AGENDA

Thursday, November 7, 2024
1:30 p.m.

23-68 KNR – Convenience Store/Deli – Major Site Plan (Preliminary) PC Decision
10816 Worton Road, Worton – Third Election District – Zoned Village

TO: Kent County Planning Commission
FROM: Carla Gerber, Deputy Director
MEETING: November 7, 2024
SUBJECT: KNR, Inc. – Preliminary Site Plan –Convenience Store/Deli

DATE: 3 MAY 2024
SCALE: 1" = 20'
PROJECT NO. 14362
SHEET: 4 OF 8

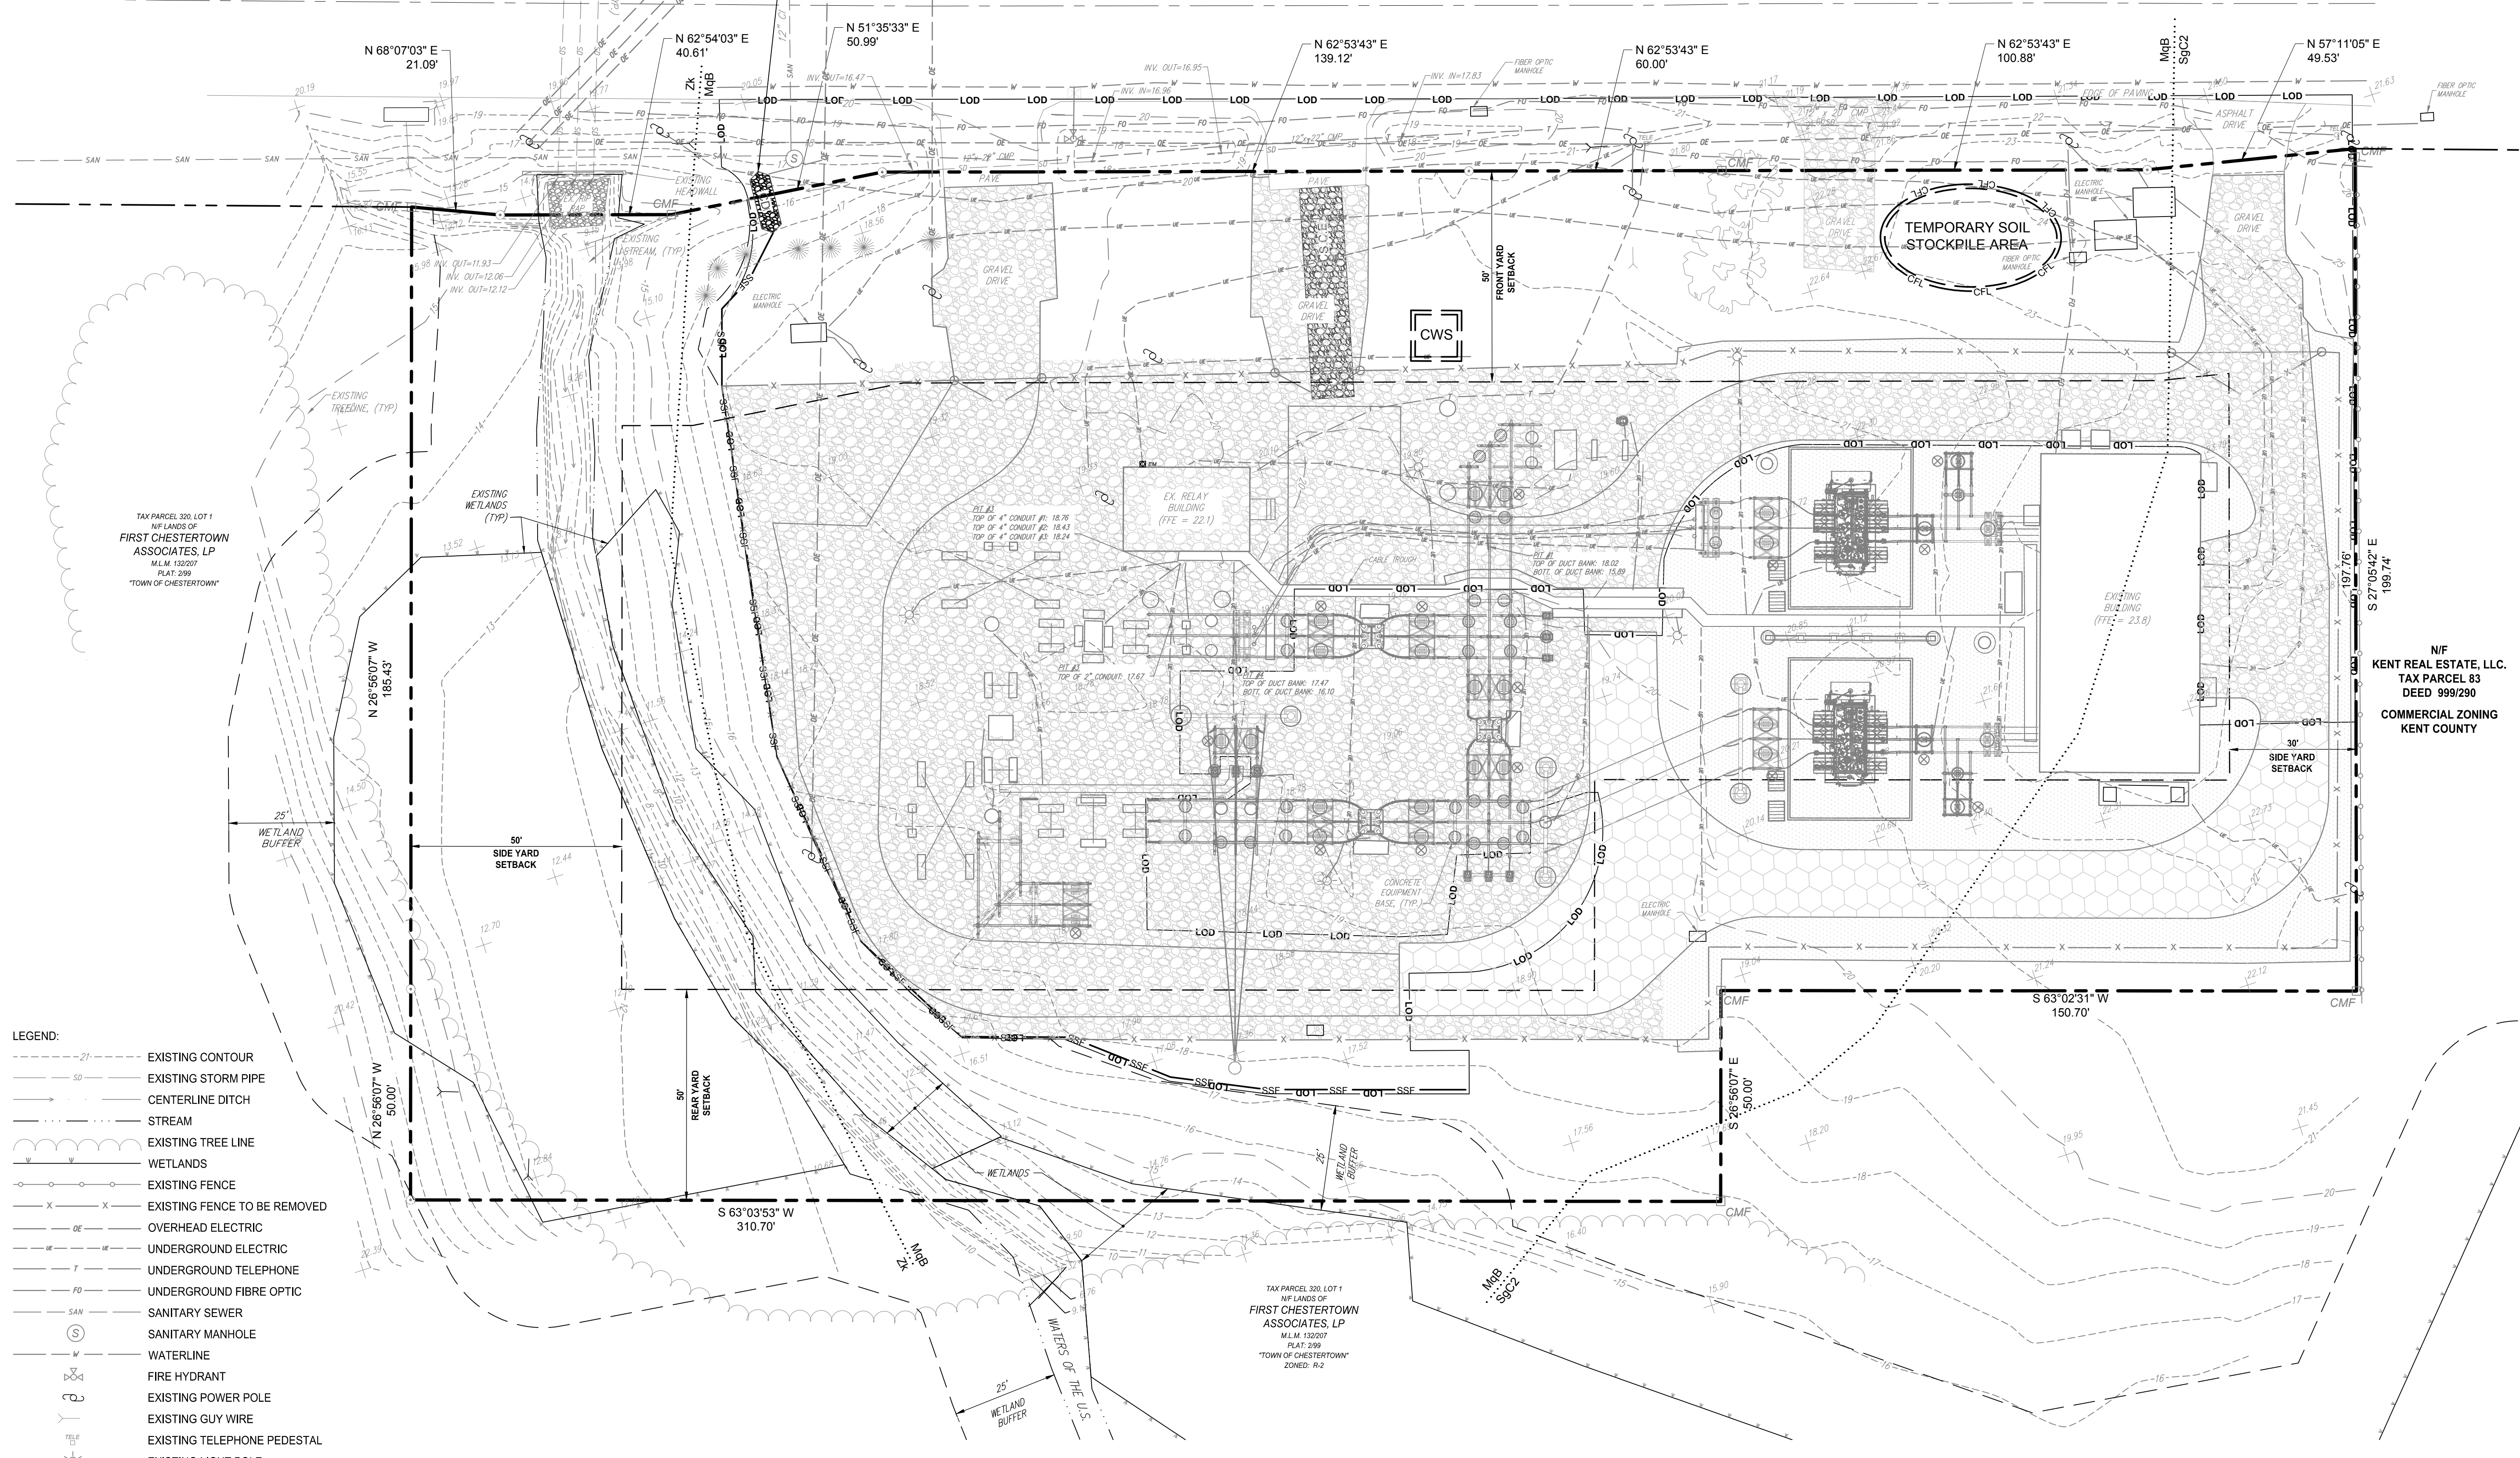
- Comment: On sheet 4, titled “Final Major Site Plan”, it states that a 6-foot chain-link fence is proposed along the rear property line. The site renderings show a panel fence on all sides. Please provide clarification regarding the type of fence proposed along the side and rear property lines.

- Comment: Sheet 4 shows a porta-potty towards the northwest section of the property. Please update site coverage on sheet 1 to reflect the proposed porta-potty.

Response: The Site Cover calculations shown on sheet 1 have been updated accordingly.
